SUBJECT: WESTINGHOUSE RESPONSES TO NRC REQUESTS FOR ADDITIONAL  
INFORMATION ON THE AP600

**NRC REQUEST FOR ADDITIONAL INFORMATION**

Figure 440.554-1 Long Term Cooling Calculation Code Stream

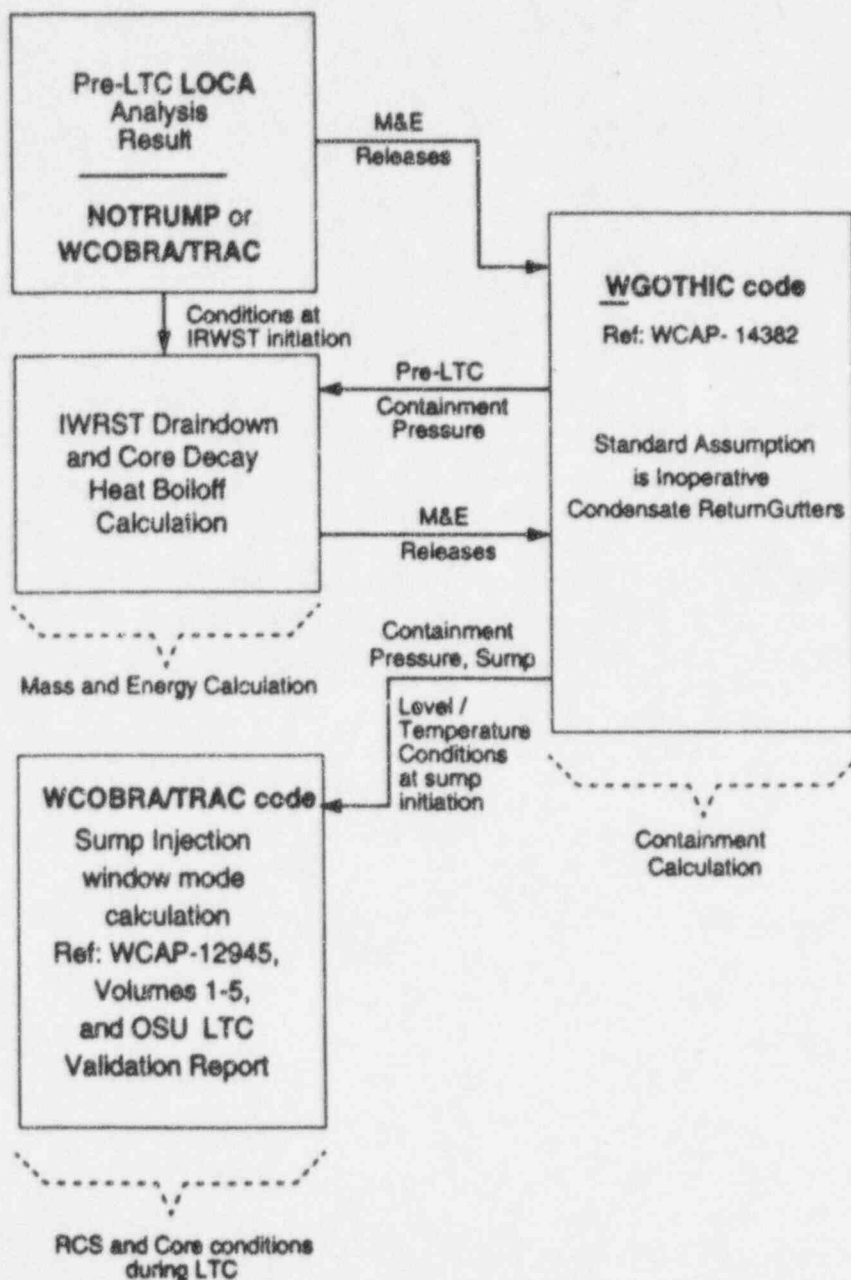
The containment is not part of the OSU simulation, the steam produced during the LTC was reintroduced as condensate into the IRWST. Containment condensation is a major part of the LTC cooling cycle. There is no discussion in LTCT-GSR-003 of the process which establishes the adequacy of the containment as a heat exchanger. In particular there is no discussion on: (1) the adequacy of the primary water to fill the containment with steam without core uncover throughout the transient (2) the interface of the GOTHIC code and WCOBRA/TRAC regarding the time dependent condensation process and (3) the coolant inventory distribution as a function of time during the transient until steady state condensation rate is achieved.

In the SSAR long-term cooling analysis, the WCOBRA/TRAC calculations of reactor coolant system performance will utilize WGOTHIC (Reference 440.554-1) predictions of AP600 containment response during postulated LOCA events. In the SSAR long-term cooling analysis methodology, WGOTHIC is executed to provide the following information for use as boundary condition input to the WCOBRA/TRAC long-term reactor coolant system window mode calculations: containment pressure, sump levels in the containment compartments, and the liquid temperatures within those compartments. WGOTHIC is executed for the entirety of the LOCA event to generate information used in the WCOBRA/TRAC long-term cooling ECCS performance analysis. The two computer codes are executed separately and interfaced as shown in the attached Figure 440.554-1 to accomplish the analysis of breaks postulated to occur in the RCS loop piping.

Referring to Figure 440.554-1, the mass and energy releases for the pre-long-term cooling portion of a SSAR LOCA transient are supplied to WGOthic from the AP600 large or small break LOCA ECCS analysis results. The draining rate of the IRWST, which is based on the minimum initial inventory and the condition at the initiation of long-term cooling, is then calculated for use in the mass and energy release determination. A specific conservatism applied in computing the mass/energy releases during the IRWST delivery period is that all of the IRWST flow injected into the reactor vessel as the tank drains to the Low-3 level setpoint is presumed to pass through the core, and in the process is heated to the saturation temperature. Additional core decay heat beyond that necessary to heat the injected flow to saturation is assumed to vaporize core liquid. In this way, the saturated liquid flow through ADS-4 flow paths is maximized, while steam flow out through ADS-4 is minimized, consistent with the decay heat model employed. As a result, the temperature of the containment sump liquid is maximized while the containment atmospheric pressure is minimized. Consistent with the OSU Facility test data, zero fluid flow is assumed through ADS Stages 1, 2 and 3 and no flow enters the PRHR heat exchanger during IRWST injection (Reference 440.554-2). This modeling maximizes the likelihood that the containment sump, which receives no subcooled break flow, contains saturated liquid at the inception of sump injection; conditions near saturation present a great challenge to the ability of sump injection to continue the removal of decay heat and to provide the core liquid throughput that precludes the concentration of boric acid in the core to any significant extent.
